ASSEMBLY ALERT: #138

SUBJECT: WING - LEADING EDGE RIVETS

MODELS AFFECTED: S-16

FIGURE AA-#138

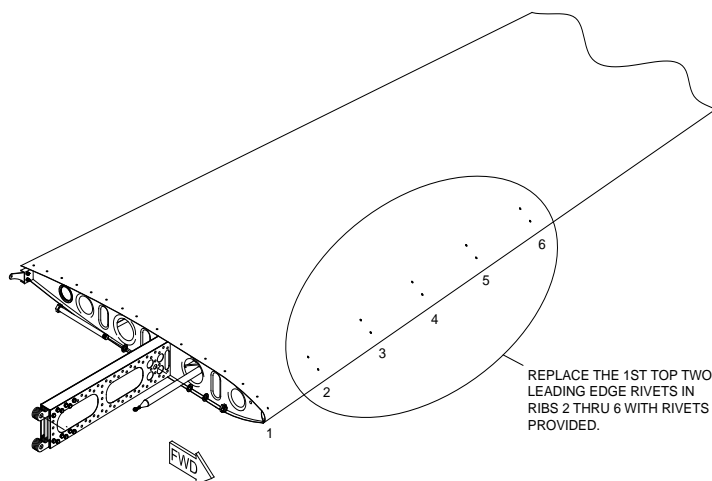
NOTE: Assembly alert applies to forward ribs #2 thru #6.

Three (3) leading edge rivets on each wing on our S-16 prototype have loosened. This is due to two (2) factors.

1. Our prototype uses .020 leading edge skins.
2. Rivets were not set properly and a gap resulted between skin and rib.

To prevent this from happening on your aircraft we recommend replacing the rivets (see Figure AA-#138) with CherryMax rivets (CR3213-41). These rivets will be shipped when in stock.
